AGENDA

March 19, 2013

MILFORD PLANNING BOARD PUBLIC HEARING ~ DRAFT ~
February 19, 2013 Board of Selectmen's Meeting Room, 6:30 PM

LOT LINE ADJUSTMENT AND SUBDIVISION PLAN OF LAND LOT 53-67-2 VITA L. VAITKUNAS REVOCABLE LIVING TRUST AND LOT 53-68 FEDERAL HILL 235 REALTY TRUST MILFORD, NEW HAMPSHIRE

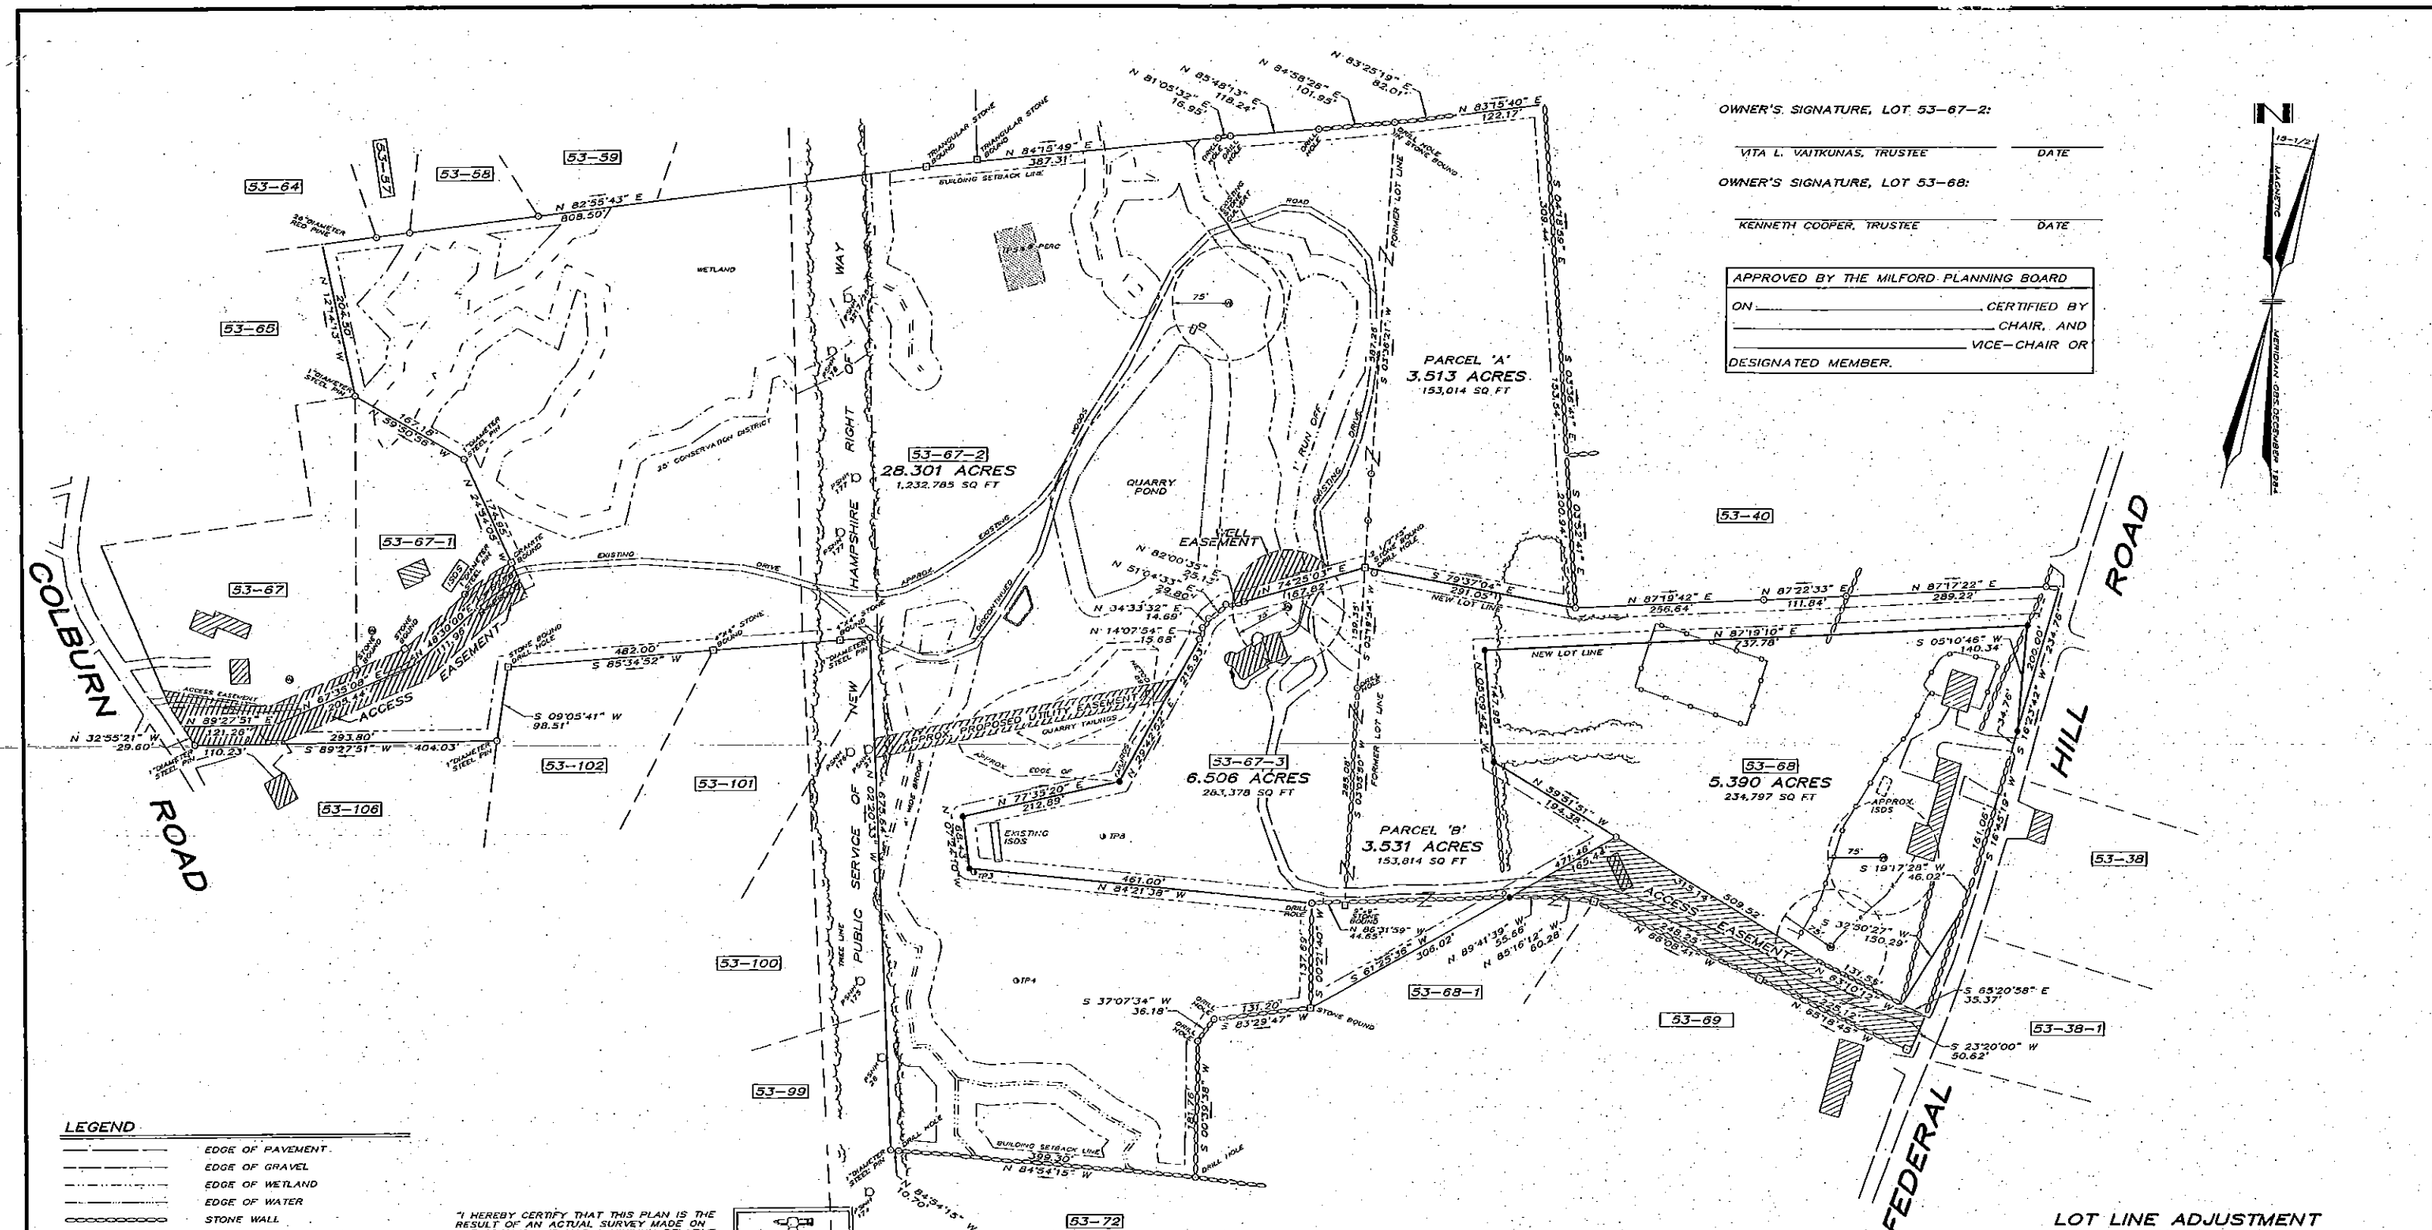
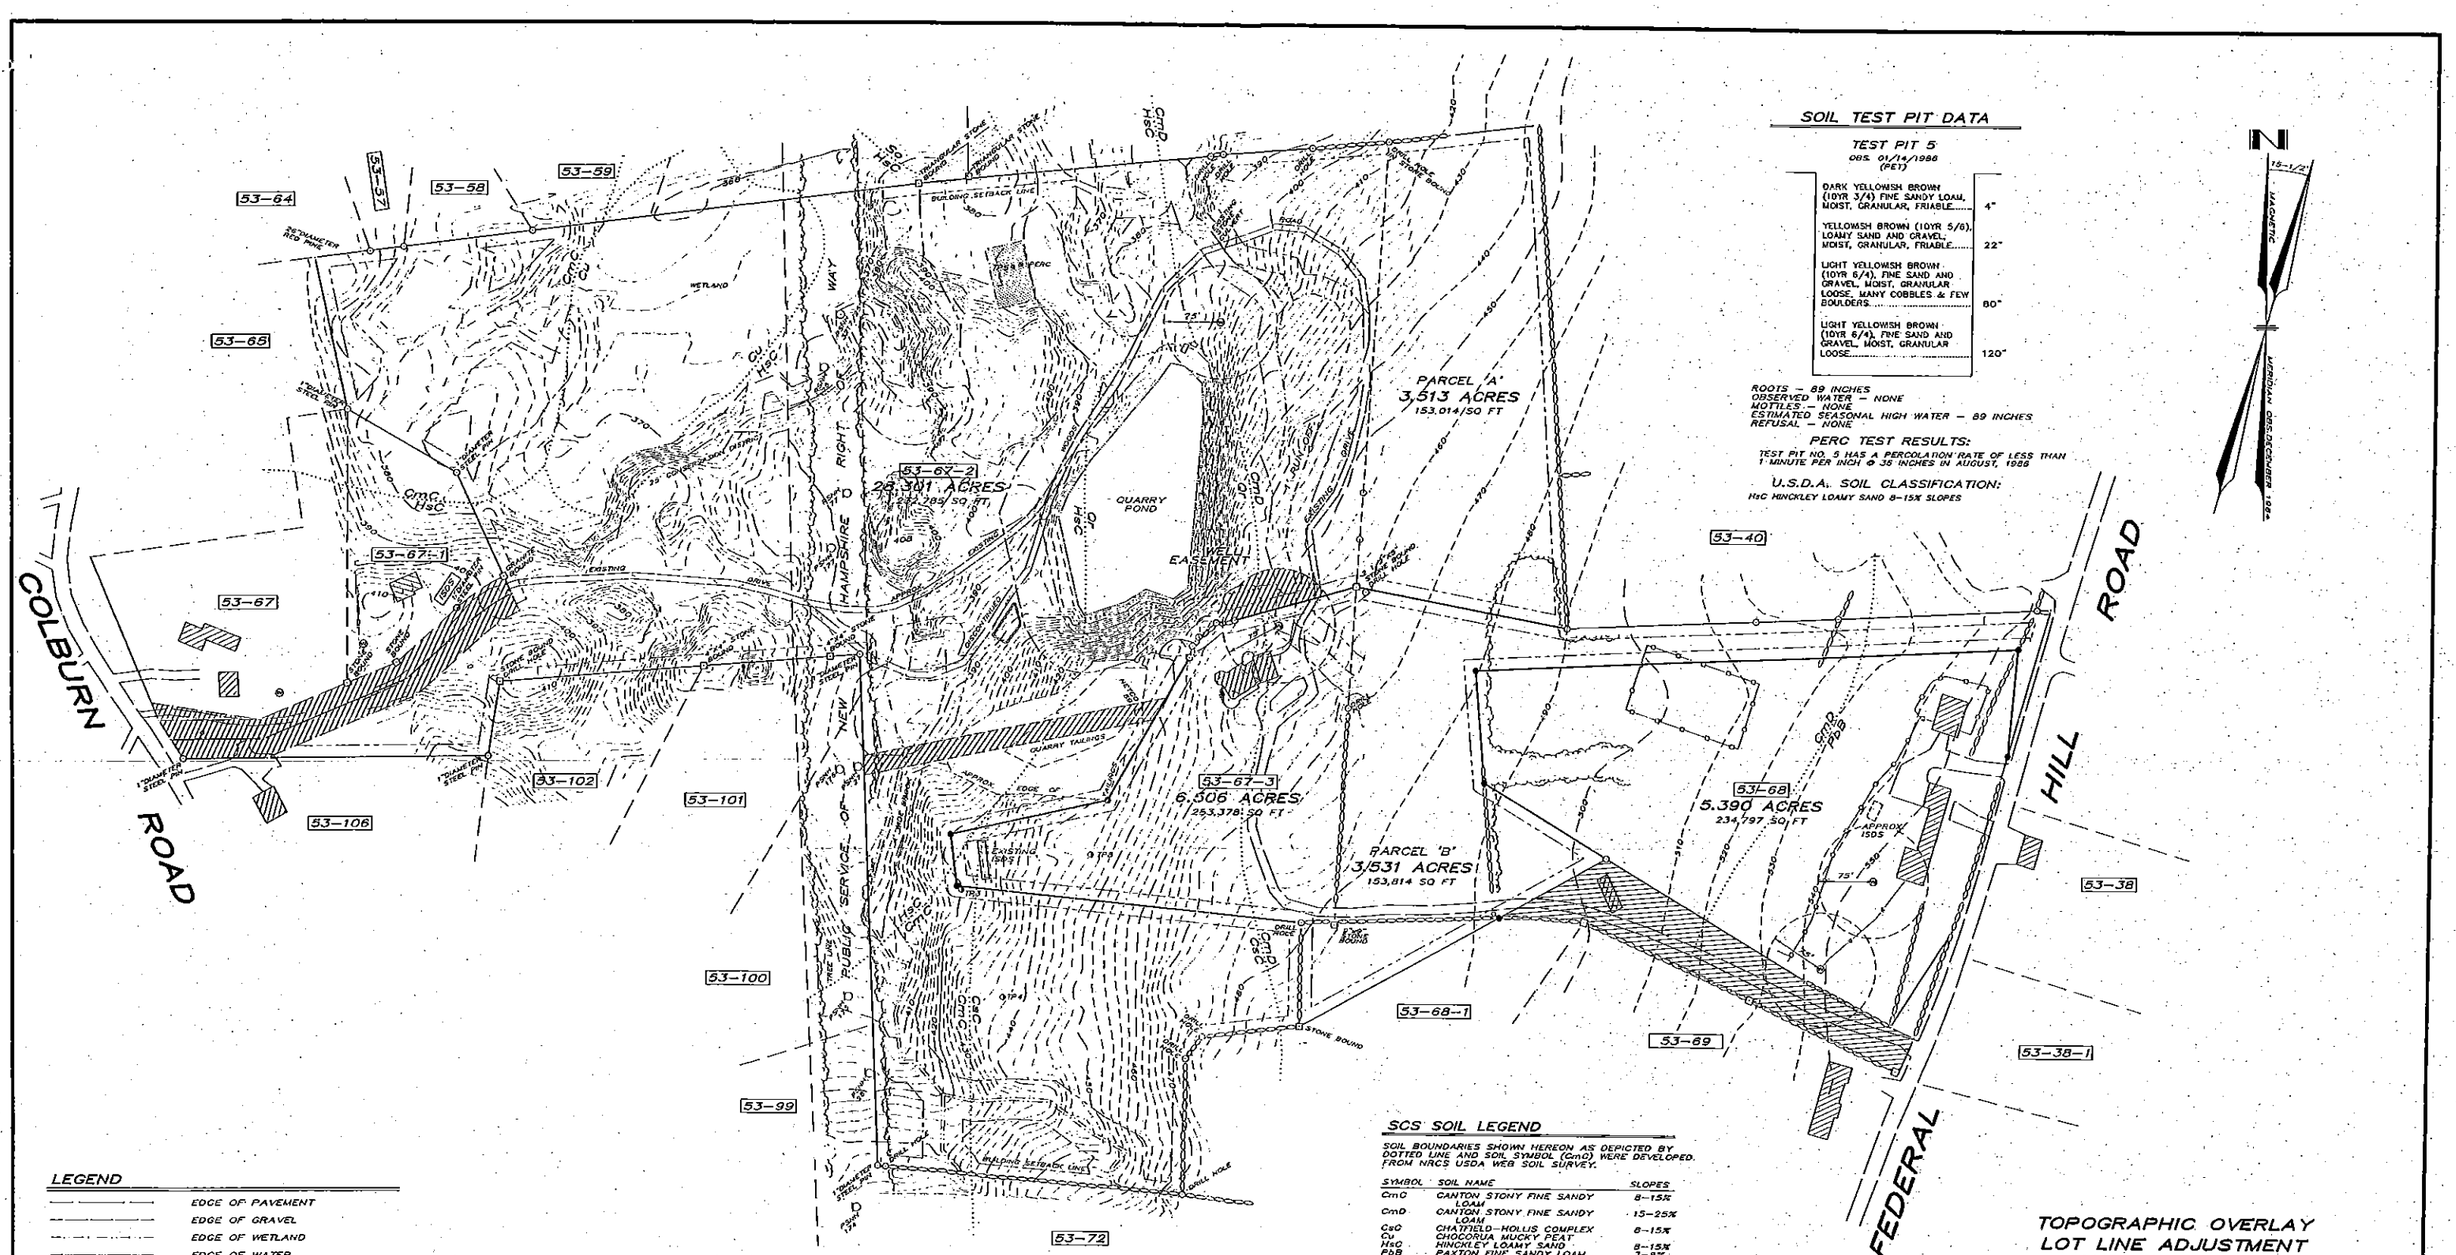
Waiver Request:
The applicant is requesting two waivers from Development Regulations Section 5.06, Submittal Requirements. The first waiver request is for locations of existing wells within 100 feet of the property in question. This request is inapplicable as an earlier version of the Minor Subdivision Application Checklist was provided on the Town Website. Current Minor Subdivision Regulations do not require the location of water supply details within 100 feet be shown on the plan. Staff is working to remove the incorrect checklist from the website and replace as necessary. The survey indicates the locations of existing wells on the affected properties along with the two lots off of Colburn road near the access easement. Since this requirement no longer exists, the Planning Board does not need to act on this waiver request.

The second waiver request from Section 5.06 is from areas of wetlands and slopes over 25%. Topography at 2 foot intervals is provided on the plan for a majority of the site demonstrating areas of steep slope. Areas of wetlands are shown on sheet 2 of 3 located in the northern and southern portions of the quarry lot (53-67-2). The Board should seek additional information from the applicant as to the location of the proposed home on lot 53-67-2 to feel comfortable that sufficient topographic information is provided to insure there is no impact on the wetlands and that steep slopes will be create problems. If the Board is comfortable with the information then full topographic detail for all the property is not required.

1. Note #14 be removed as the Growth Management Ordinance is no longer enforced;
2. A note be added to the plan stating that a well radius easement will be required from the property owners of lot 53/67-2;
3. A note be added stating lot 53-67-2 will require approval of a Stormwater Management Permit prior to commencement of site work if over 5,000 SF of area will be disturbed.
4. A note added to the plan stating the intended points of access for the new lot;
5. All boundary monumentation be set as noted on the plan;
6. Revise note #7 to read "Minimum Open Space for all uses other than single-family and two-family dwellings is 30%;
7. All applicable easement documentation be summited to the Town of Milford;

TAX MAP 44 LOT 11
SUBDIVISION PLAN
583 NH ROUTE 101A
MILFORD, NEW HAMPSHIRE
OWNED BY & PREPARED FOR
JOHN SAMONAS

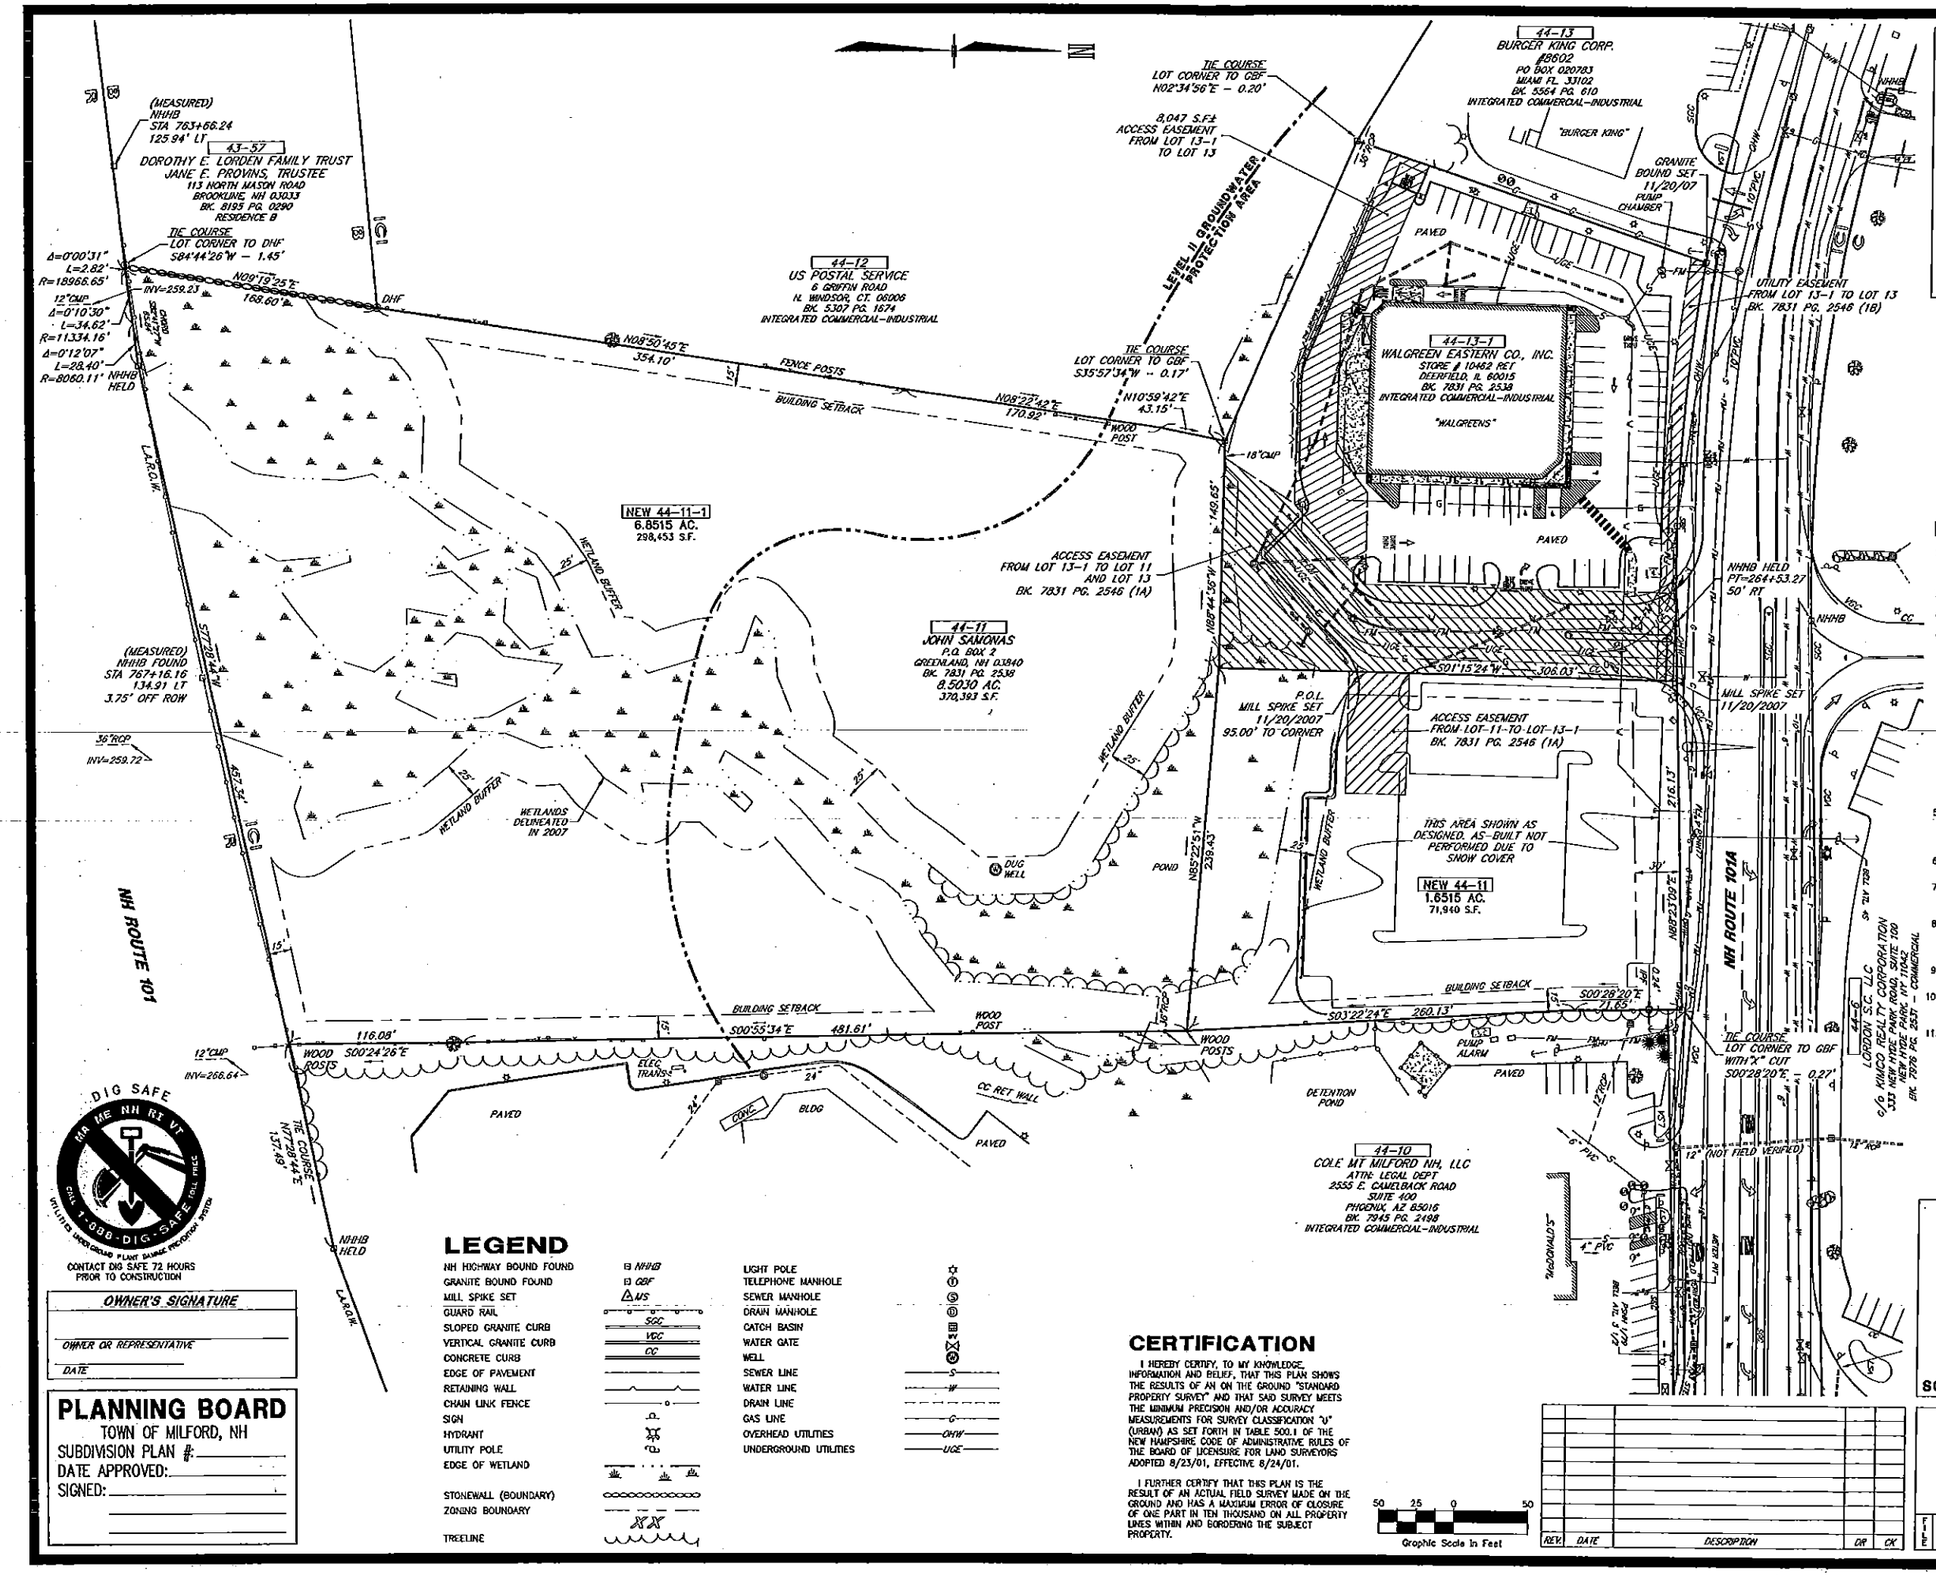
1. A note be added stating the new lot (44/11-1) is subject to include Police Impact fees (to be determined at time of building permit application);
2. The road name on the plan should read as Nashua Street not Rt 101A;
3. Note #4 should include the ZBA case # 2012-29;
4. The new lot line should be labeled as "new lot line";
5. A note stating that development of lot 44-11-1 shall be subject to appropriate local and state approvals for wetlands crossing and buffer disturbance;
6. Note #11 should be removed as the Growth Management Ordinance is no longer in place;
7. Add a note stating each lot will require approval of a Stormwater Management Permit prior to commencement of site work if over 5,000 SF of area will be disturbed.
